Subject: Application for Licensee Proposed Modification to the Generation License under NEPRA Licensing (Application, Modification, Extension and Cancellation) Procedure Regulations, 2021, on behalf of 2x660 MW Thar Coal Block-1 Power Generation Company (Private) Limited

APPLICATION FOR MODIFICATION OF
GENERATION LICENSE NO. IGSP/L/74/2017 DATED JANUARY 05, 2017

THAR COAL BLOCK-1 POWER GENERATION COMPANY
(PRIVATE) LIMITED

OEM Datasheets and Start-up Curves

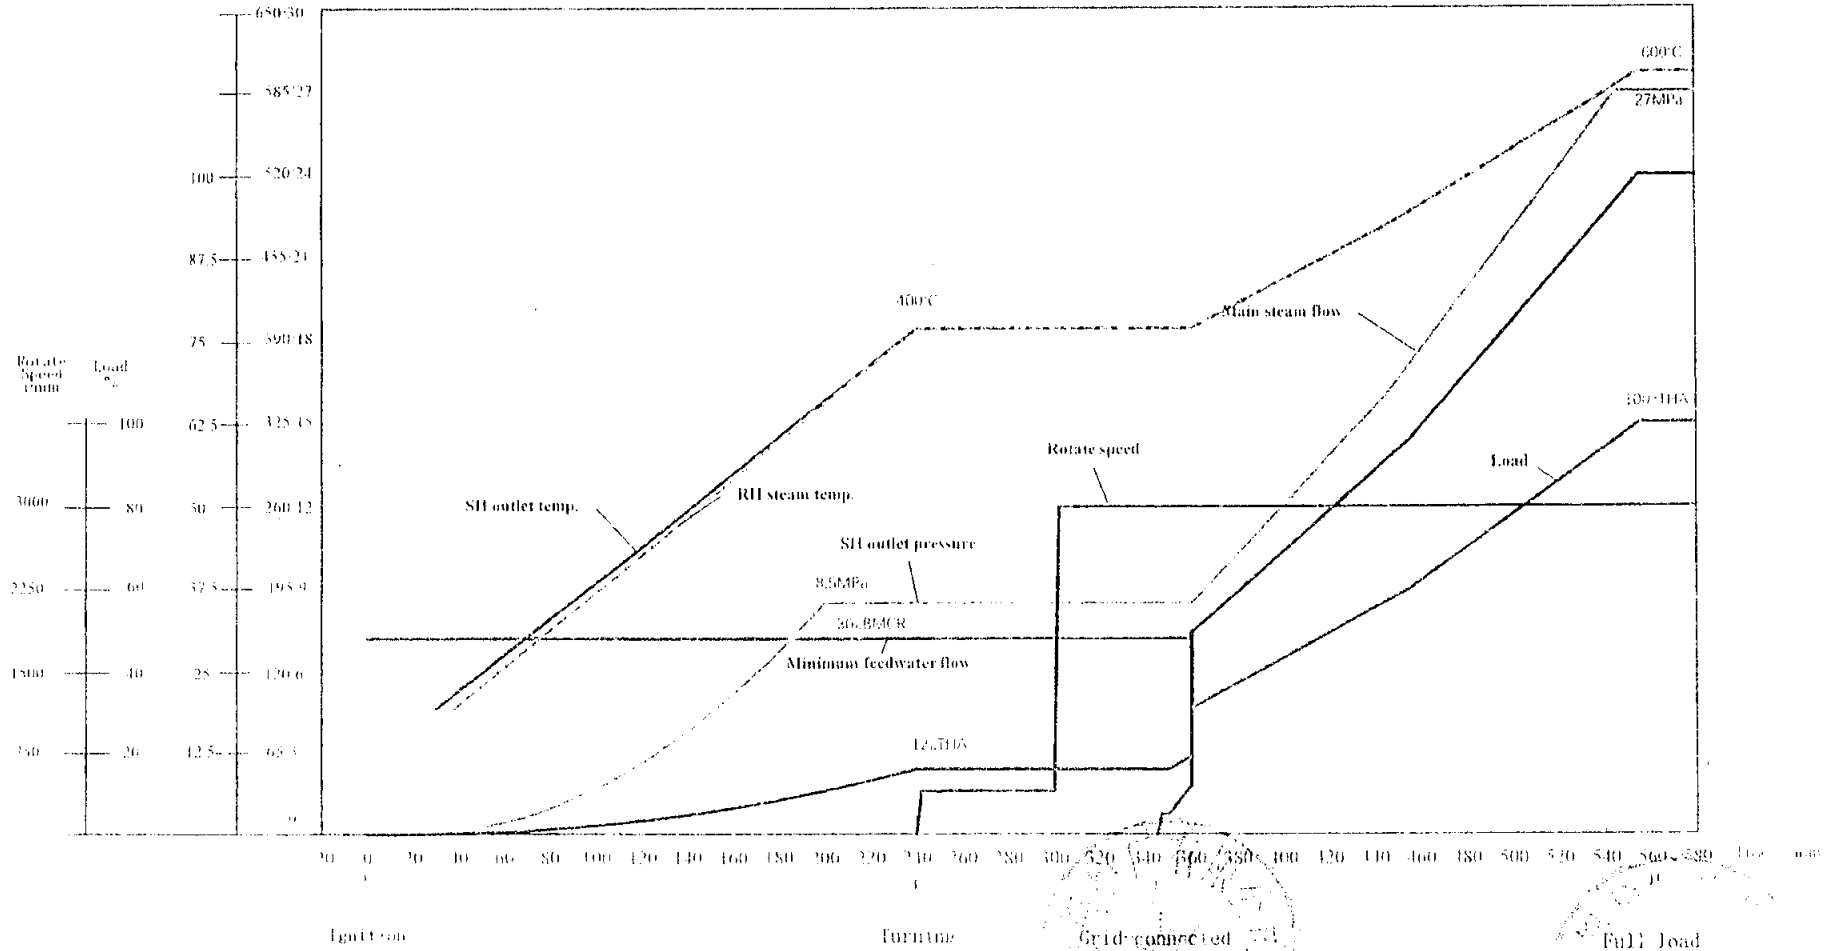
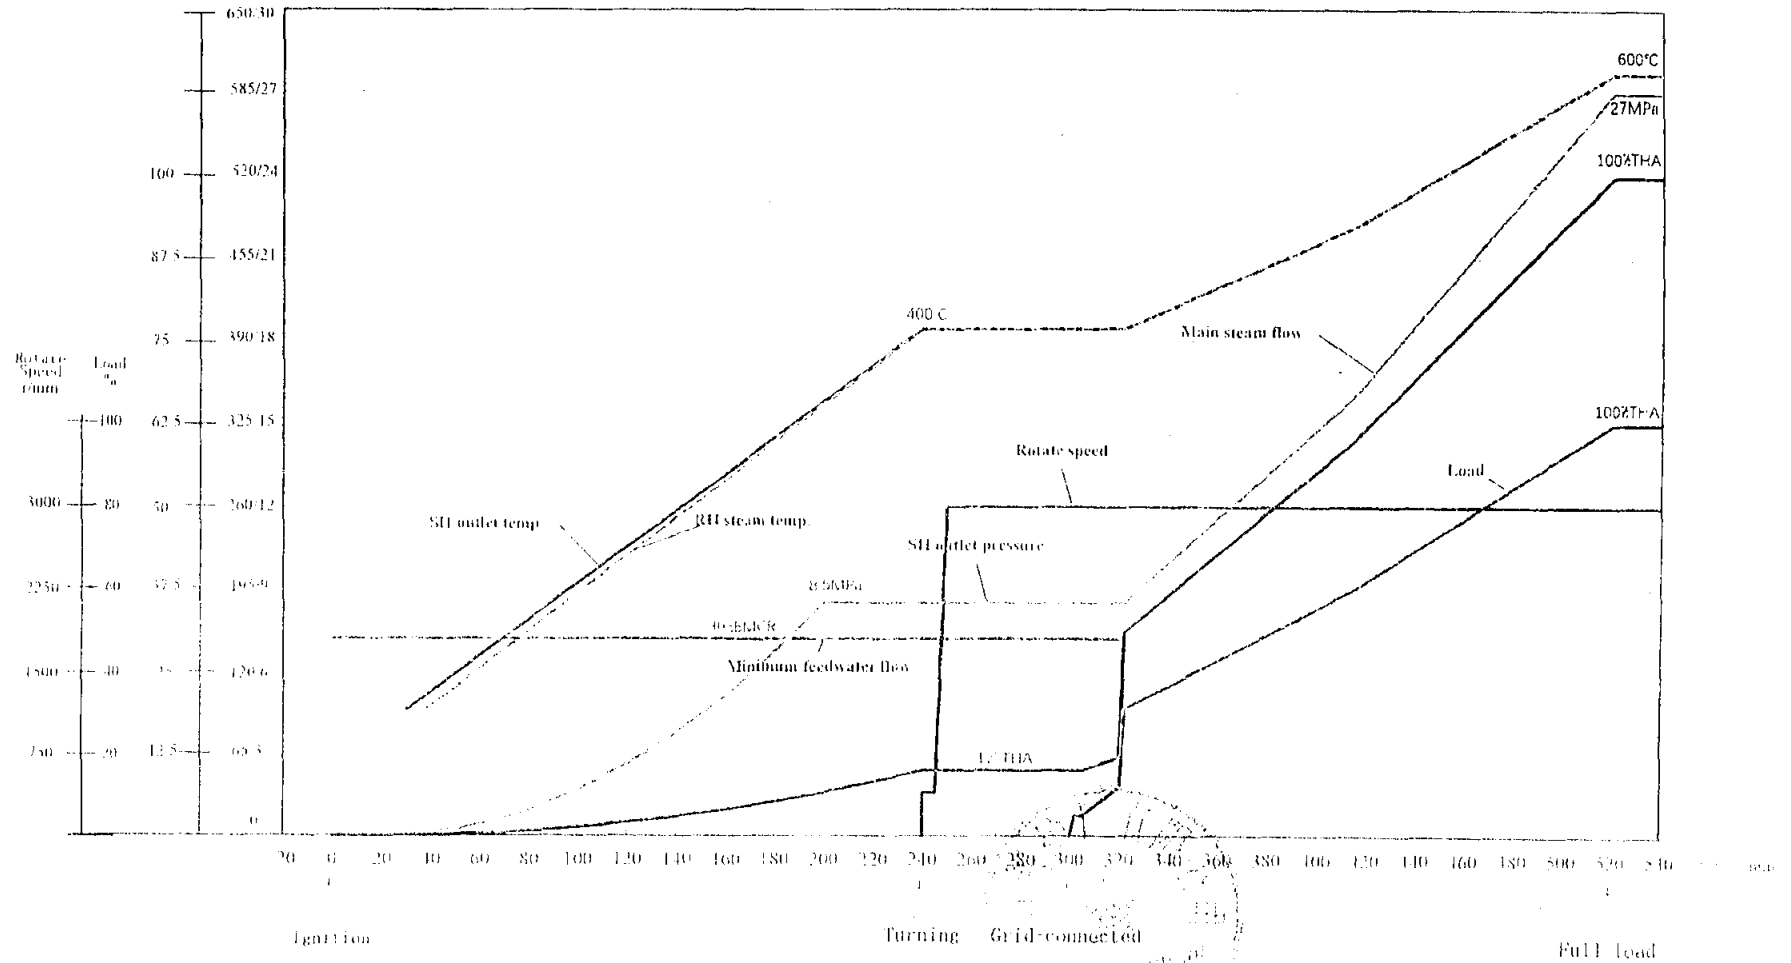
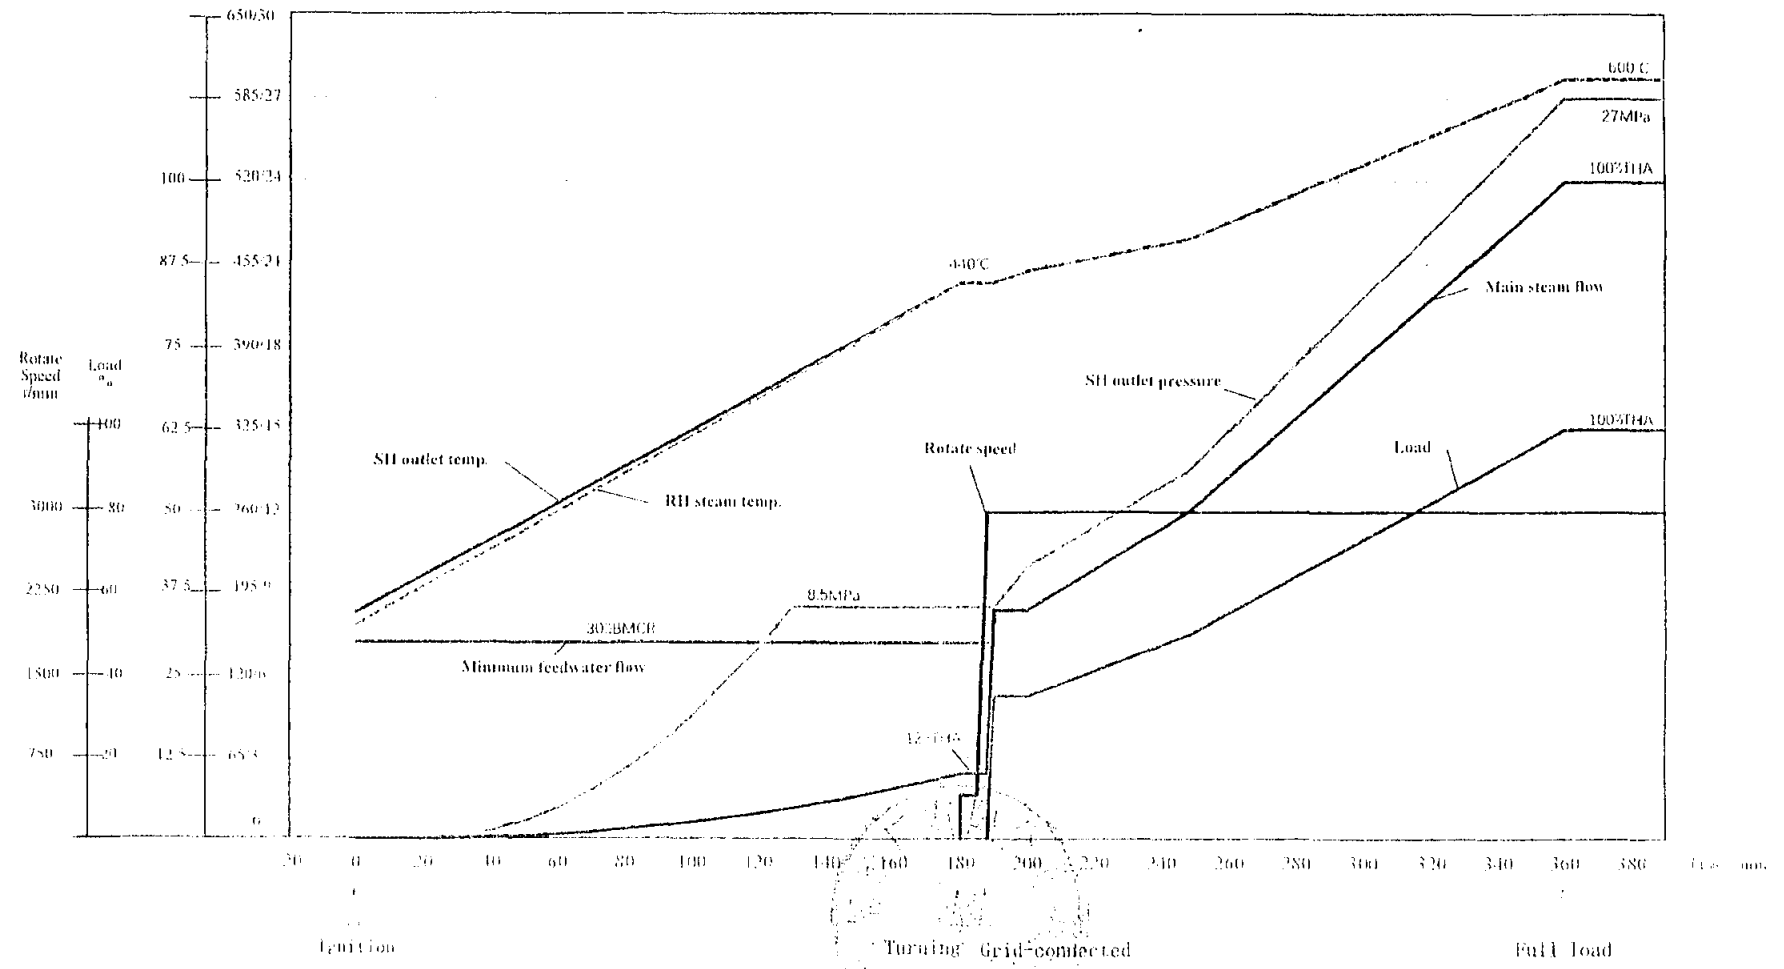
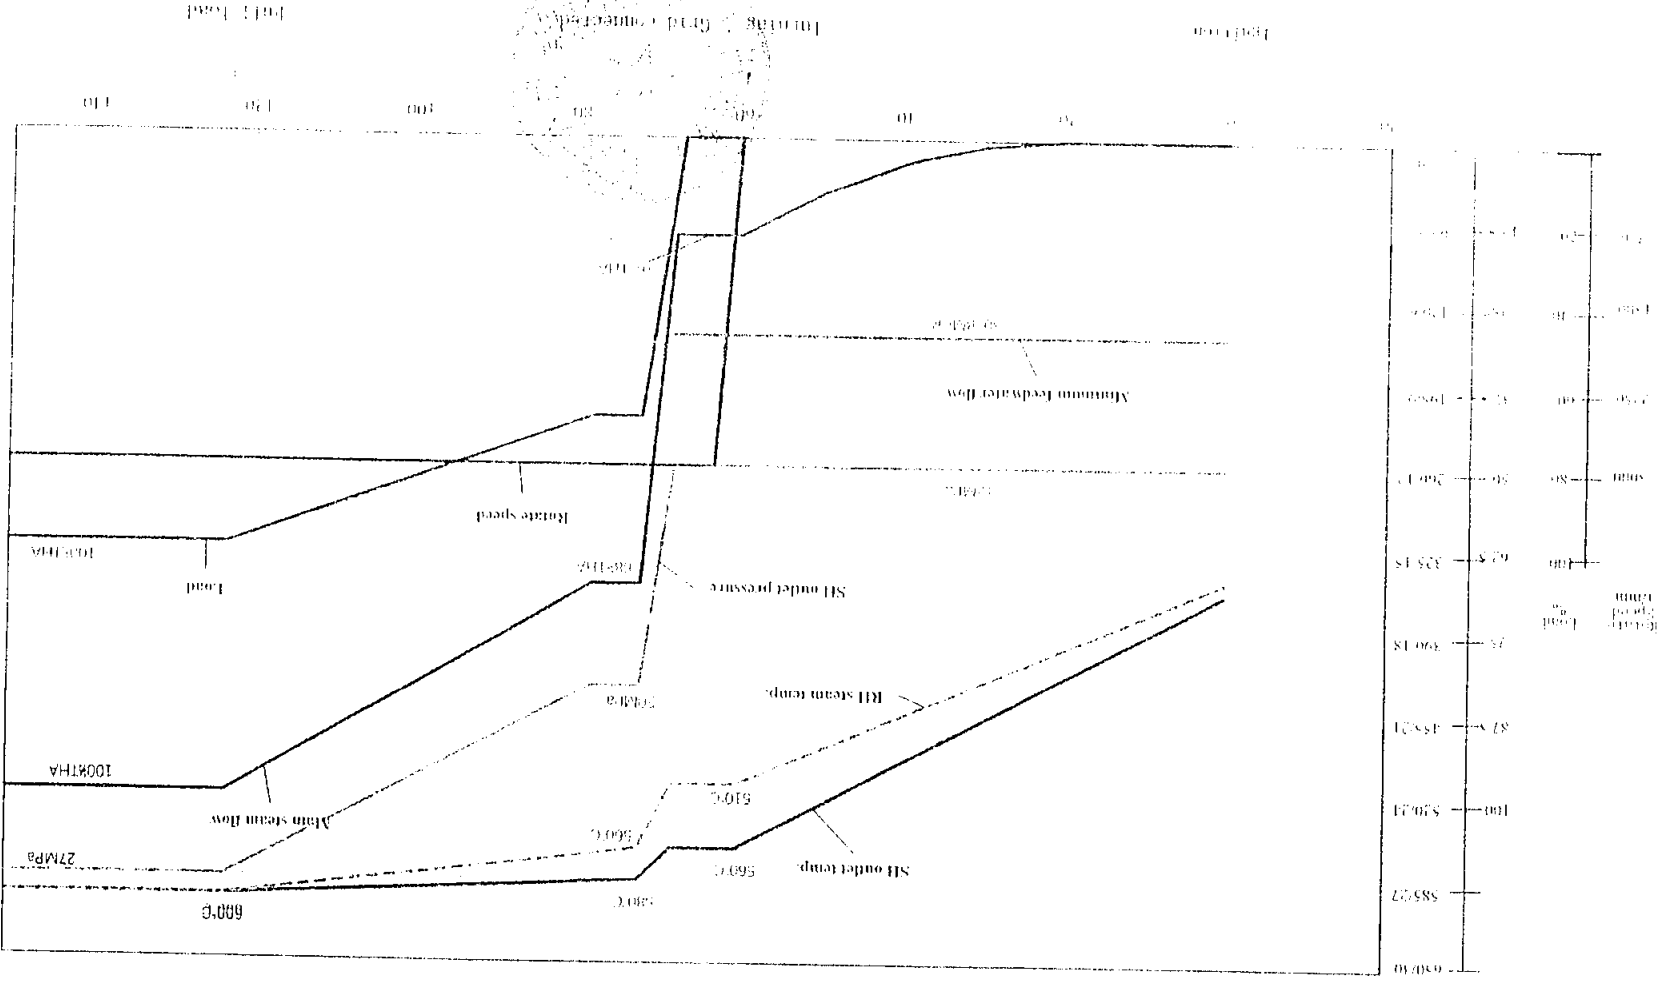
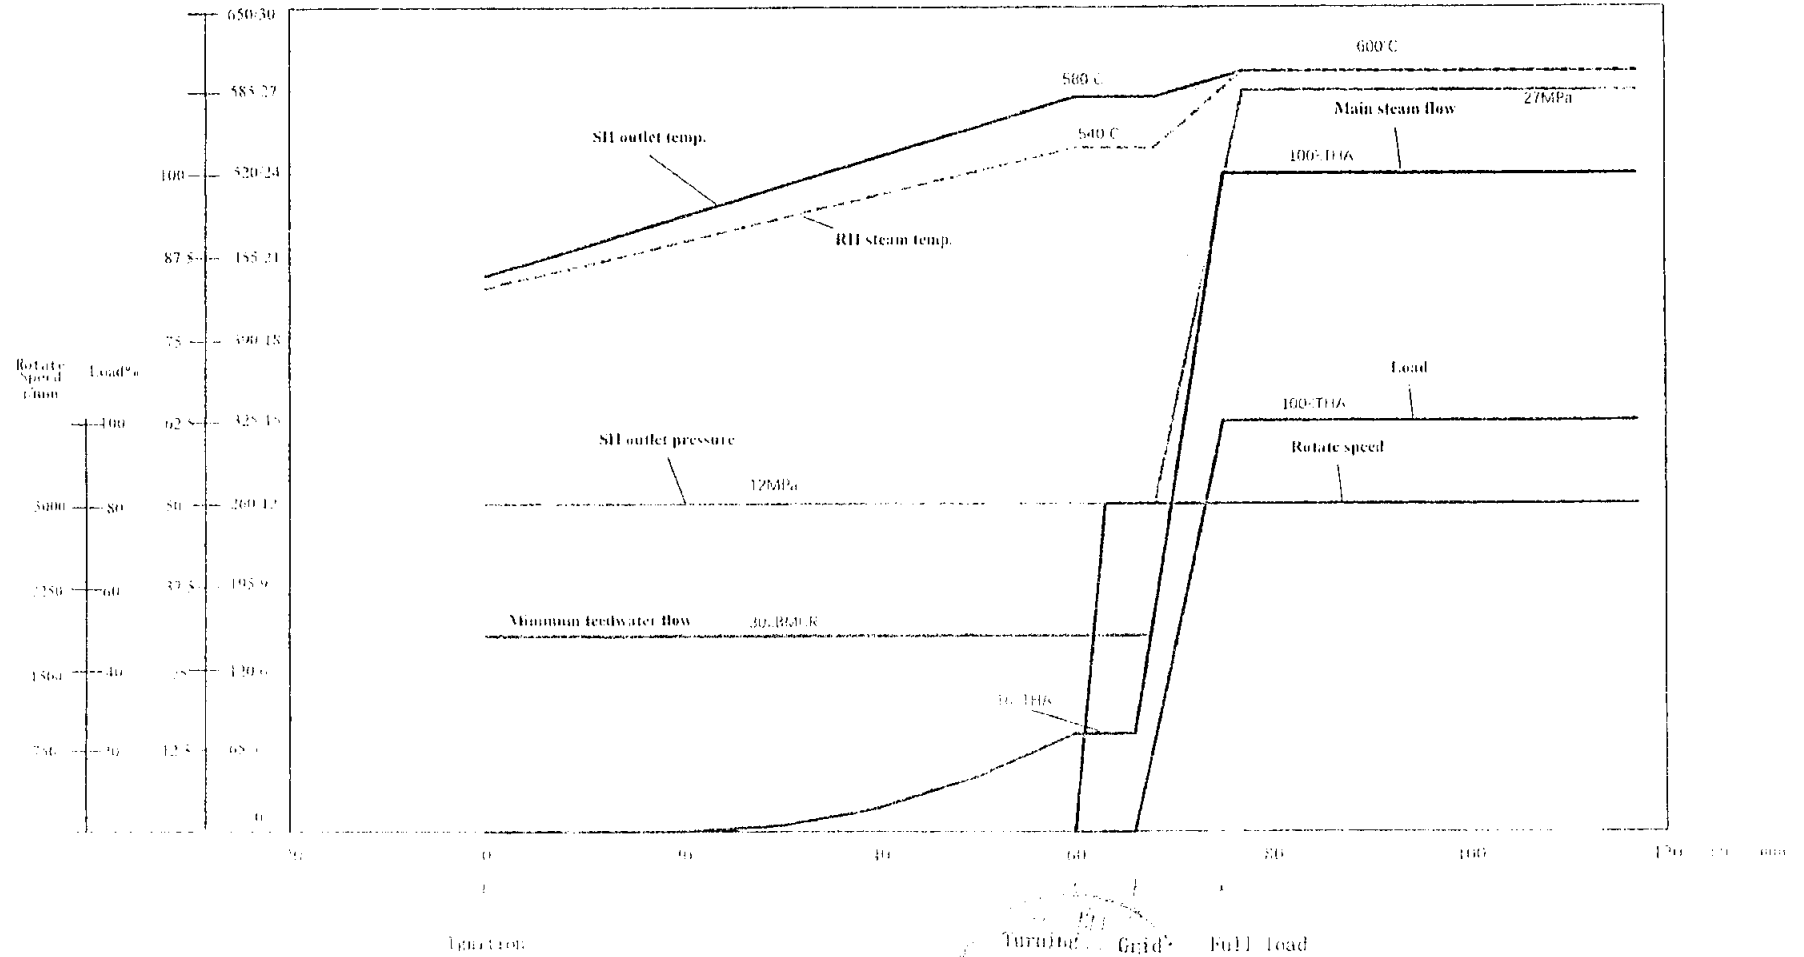
It is further added that as per the standard practice, OEM of TCB-1 project has recommended different ramping rates along with the holding time at different loading conditions during startup and normal operation of Unit(s) as set out in table 1(a) and table 1(b) of this application, which is required to be complied necessarily to ensure safe and reliable operation of the Power Plant. Moreover, the minimum stable loading of the Power Plant is 50%. The relevant OEM documents and recommendations justifying the proposed modification to the Ramping Rates are attached herewith as Annex-I for reference.

In order to ensure safe and reliable operation of each unit of the Power Plant, following modifications to the time required for synchronization to the Grid is applied based on the technical specifications and OEM recommendations, (attached in Annex-I of this Application) taking into account an efficient, safe and reliable operation of the Complex. Following is the brief explanation for the Time Required to Synchronize to Grid with respect to each type of start-up:
